# Technical Note TN-2879c-SR

# TM9300 and TP9300 DMR Firmware v2.22.02 TM8200, TM9300, TP9300 Programming App v2.22.0.18 Tx9000 Calibration Application v2.30.8.322

14 May 2019

This Technical Note applies to Cadence Release **DMR-1903 (R19.1)**. Firmware **v2.22.02.0042** for the TM9300 DMR mobile radios and TP9300 DMR portable radios is supported by:

JIRA-TRM-38882: TM9300 HHCH RSSI 'Value' now correctly right-aligns on the screen

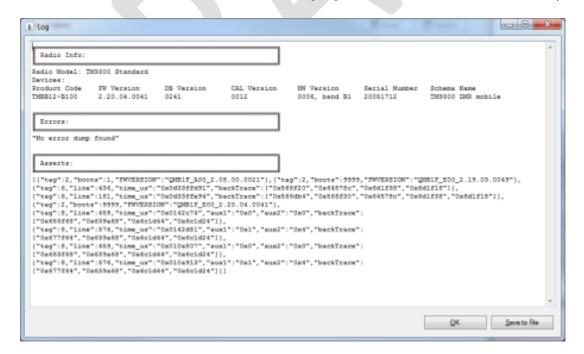
Previously with this enabled it would push some of the RSSI Number value beyond the HHCH screen edge (see right). This was not noted with the Large Control Head or TP9300 displays
